OICA proposal for Electrical Safety In-Use: comparison between previous and new proposal

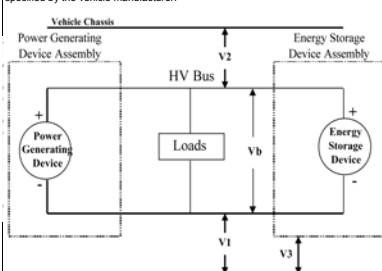
2-1	Measurement method using DC voltage from off-vehicle sources	2-1	Measurement method using DC voltage from off-vehicle sources	
2-1-1	Measurement instrument	2-1-1	Measurement instrument	
2-1-2	Measurement method	2-1-2	Measurement method	
2-2	Measurement method using the vehicle's own RESS as DC voltage source	2-2	Measurement method using the vehicle's own RESS as DC voltage source	
2-2-1	Test vehicle conditions	2-2-1	Test vehicle conditions	
2-2-2	Measurement instrument	2-2-2	Measurement instrument	
2-2-3	Measurement method	2-2-3	Measurement method	
2-2-3-1	First step	2-2-3-1	First step	
	<p>The voltage is measured as shown in Figure 1 and the HV Bus voltage (Vb) is recorded. Vb shall be must be equal to or greater than the nominal operating voltage specified by the vehicle manufacturer.</p> 		<p>The high voltage bus shall be energized by the vehicle's own RESS and/or energy conversion system, and the voltage level throughout the test shall be at least the nominal operating voltage as specified by the vehicle manufacturer.</p>  <p>Figure 1: Measurement of Vb, V1, V2</p>	- Changed the words to those used in the main body.

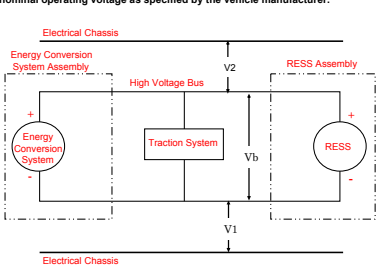
2-2-3-2	Second step	2-2-3-2	Second step	
2-2-3-3	Third step	2-2-3-3	Third step	
2-2-3-4	Fourth step	2-2-3-4	Fourth step	
	<p>If V1 is greater than or equal to V2, insert a standard known resistance (Ro) between the negative side of the high voltage bus and the vehicle chassis. With Ro installed, measure the voltage (V1') between the negative side of the high voltage bus and the vehicle chassis (see Figure 2). Calculate the electrical isolation (Ri) according to the following formula:  <math>Ri = Ro \cdot (Vb/V1' - Vb/V1)</math> or <math>Ri = Ro \cdot Vb \cdot (1/V1' - 1/V1)</math></p> 		<p>If V1 is greater than or equal to V2, insert a standard known resistance (Ro) between the negative side of the high voltage bus and the electrical chassis. With Ro installed, measure the voltage (V1') between the negative side of the high voltage bus and the electrical chassis (see Figure 2). Calculate the electrical isolation (Ri) according to the following formula:  <math>Ri = Ro \cdot (Vb/V1' - Vb/V1)</math> or <math>Ri = Ro \cdot Vb \cdot (1/V1' - 1/V1)</math></p>  <p>Figure 2: Measurement of V1'</p>	- Changed the words to those used in the main body.

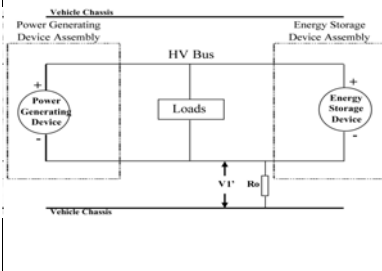
<p>If V2 is greater than V1, insert a standard known resistance (Ro) between the positive side of the high voltage bus and the vehicle chassis. With Ro installed, measure the voltage (V2') between the positive side of the high voltage bus and the vehicle chassis (see Figure 3). Calculate the electrical isolation (Ri) according to the formula shown. Divide this electrical isolation value (in ohms) by the nominal operating voltage of the high voltage bus (in volts). Calculate the electrical isolation (Ri) according to the following formula:  <math>Ri = Ro \cdot (Vb/V2' - Vb/V2)</math> or <math>Ri = Ro \cdot Vb \cdot (1/V2' - 1/V2)</math></p> 		<p>If V2 is greater than V1, insert a standard known resistance (Ro) between the positive side of the high voltage bus and the electrical chassis. With Ro installed, measure the voltage (V2') between the positive side of the high voltage bus and the electrical chassis (see Figure 3). Calculate the electrical isolation (Ri) according to the formula shown. Divide this electrical isolation value (in ohms) by the nominal operating voltage of the high voltage bus (in volts). Calculate the electrical isolation (Ri) according to the following formula:  <math>Ri = Ro \cdot (Vb/V2' - Vb/V2)</math> or <math>Ri = Ro \cdot Vb \cdot (1/V2' - 1/V2)</math></p>  <p>Figure 3: Measurement of V2'</p>	- Changed the words to those used in the main body.
